## **ADDENDUM #1**

### **State of Vermont Military Department 3/172 MEP Parking Improvements EAFR, Jericho, VT**

Addendum Date: September 14, 2022

**SK-1**

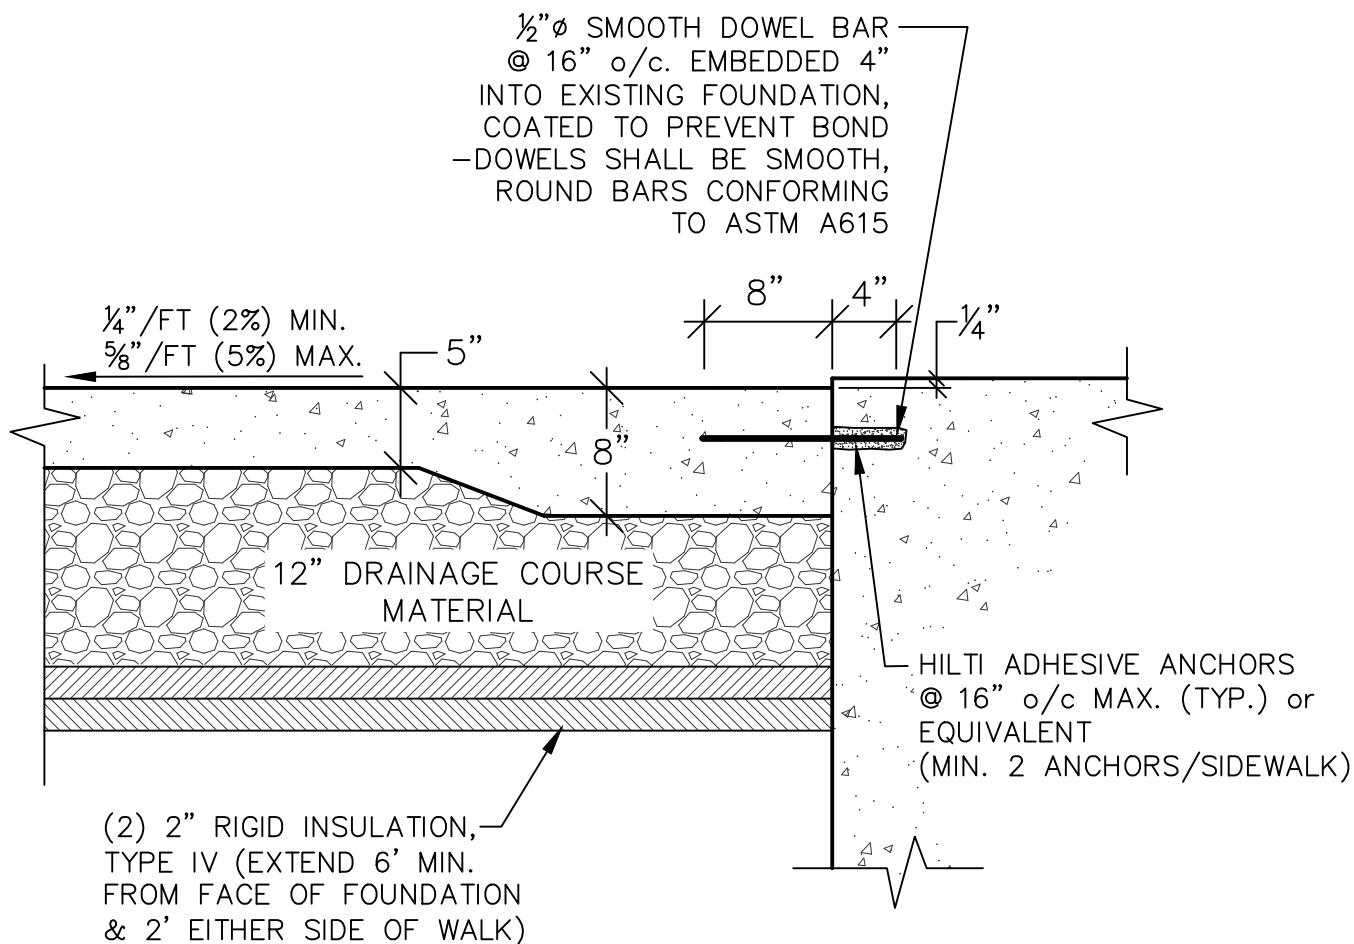
1. The following items are attached:
  - a. Pre-bid sign in sheet (1 page).
  - b. Summary of the Build America, Buy America Act (1 page).
  - c. SK-1 for the new sidewalk at the buildings.
2. *Clarification* – Project to be completed by August 31, 2023.
3. *Demo Materials*
  - a. All concrete to be removed offsite.
4. *Reminders* – Note 1 on sheet L-1 for Contractor to hire a private utility locating firm for location of Owner owned utilities and Note 18 for Contractor responsible for obtaining testing and inspection services.
5. *Clarification* – All of the shaded sidewalk shown on drawing C1.4 is to be replaced including sidewalk to the flagpole and two sidewalks to building 302. Also see attached detail for the sidewalk at the existing buildings.

## NEW SIDEWALK @ EXISTING FOUNDATION
